Access Compliance Report Public Rights-of-Way (Curb Ramps)

Intersection ID: 43662 Location: NE ADA ID: 68F91110A37B Ramp Type: Perp Initial Pass/Fail: Fail **Overall Compliance: No** Severity Score: 13.75

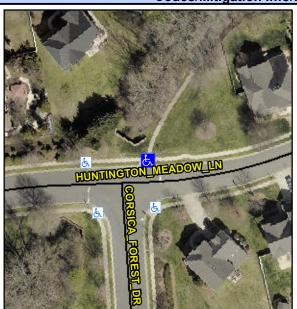
Possible Solution			
Possible Solutions:	<u>c</u>		
Remove & Replace Entire Ramp.			
·	Y		
	N		
	N		
	N		
	N		
Surveyor Notes:	N		
N/A	N		
	N		
	N		
	N		
PROW/ADA:	N		
R304.2.2, R304.5.3	N		
•	N		
	N

Field Measurements/Component Compliance							
Comp	liance Description	Data	Comp	liance Description	Data		
N/A	Ramp Length (in)	94.0	No	Ramp Slope (%)	9.8		
Yes	Ramp Width (in)	48.0	No	Ramp XSlope (%)	2.3		
N/A	Flare Type LT	N/A	N/A	Flare Type RT	N/A		
N/A	Flare Slope LT (%)	N/A	N/A	Flare Slope RT (%)	N/A		
N/A	Flare Traversable LT?	N/A	N/A	Flare Traversable RT?	N/A		
N/A	Landing Length (in)	N/A	N/A	DWS Provided?	N/A		
N/A	Landing Width (in)	N/A	N/A	DWS Contrast?	N/A		
N/A	Landing Slope (%)	N/A	N/A	DWS Length (in)	N/A		
N/A	Landing X Slope (%)	N/A	N/A	DWS Full Width?	N/A		
N/A	Landing Curb? (Y/N)	N/A	N/A	DWS Offset (in)	N/A		
N/A	Shared Landing?	N/A					
N/A	Gutter Ponding?	N/A	N/A	Gutter Slope (%)	N/A		
N/A	Gutter Lip Ht (in)	N/A	N/A	Gutter X Slope (%)	N/A		
N/A	Painted X Walk1?	No	N/A	Painted X Walk2?	N/A		
	X Walk 1 Direction	To S		X Walk 2 Direction	N/A		
N/A	X Walk 1 Width (in)	N/A	N/A	X Walk 2 Width (in)	N/A
